ARKANSAS NUCLEAR ONE, UNIT 1

AMENDMENT TO FACILITY OPERATING LICENSE

Amendment No. 83
License No. DPR-51

ATTACHMENT TO LICENSE AMENDMENT NO. 83

Figure 3.1.2-1

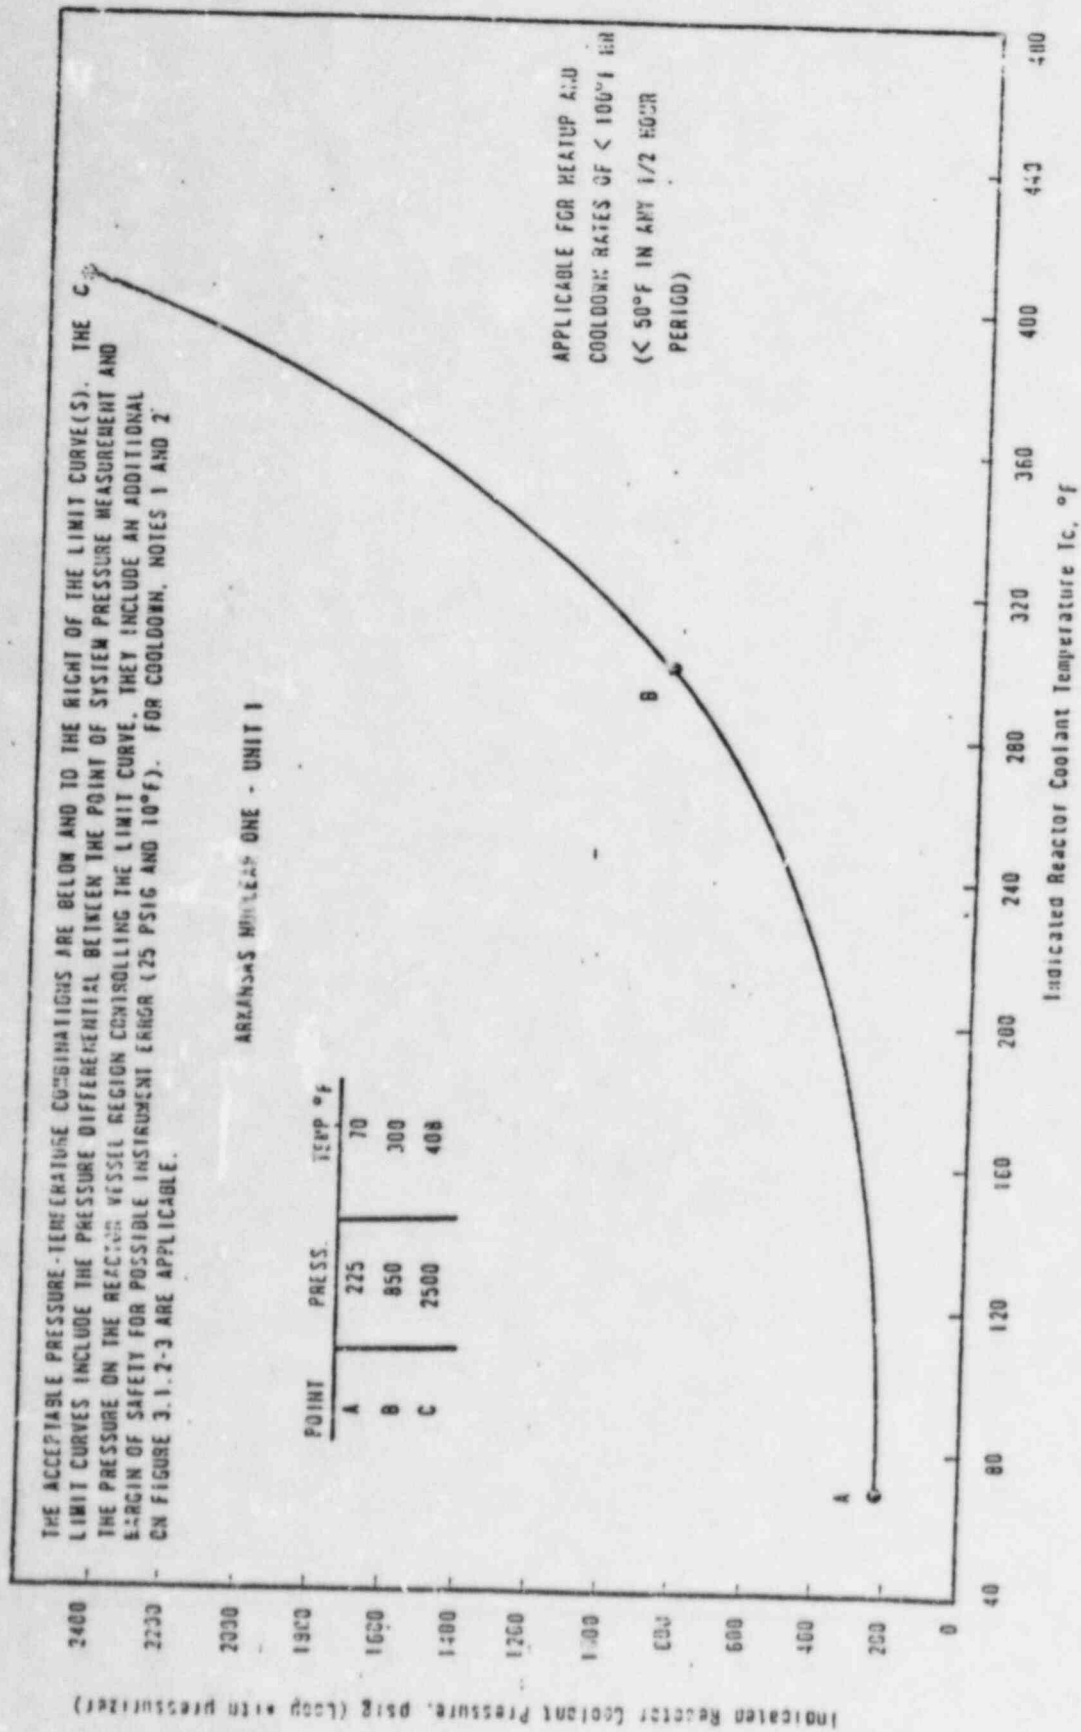
Figures 3.1.2-1, 3.1.2-2, and 3.1.2-3 present the pressure-temperature limit curves for hydrostatic test, normal heatup, and normal cooldown respectively. The limit curves are applicable through the fifteenth effective full power year of operation. These curves are adjusted by 25 psi and 10F for possible errors in the pressure and temperature sensing instruments. The pressure limit is also adjusted for the pressure differential between the point of system pressure measurement and the limiting component for all operating reactor coolant pump combinations.

The pressure-temperature limit lines shown on Figure 3.1.2-2 for reactor criticality and on Figure 3.1.2-1 for hydrostatic testing have been provided to assure compliance with the minimum temperature requirements of Appendix G to 10CFR50 for reactor criticality and for inservice hydrostatic testing.

- 3.1.2.7 Prior to reaching fifteen effective full power years of operation, Figures 3.1.2-1, 3.1.2-2 and 3.1.2-3 shall be updated for the next service period in accordance with 10CFR50, Appendix G, Section V.B. The service period shall be of sufficient duration to permit the scheduled evaluation of a portion of the surveillance data scheduled in accordance with Specification 4.2.7. The highest predicted adjusted reference temperature of all the beltline region materials shall be used to determine the adjusted reference temperature at the end of the service period. The basis for this prediction shall be submitted for NRC staff review in accordance with Specification 3.1.2.8. The provisions of Specifications 3.0.3 and 3.0.4 are not applicable.
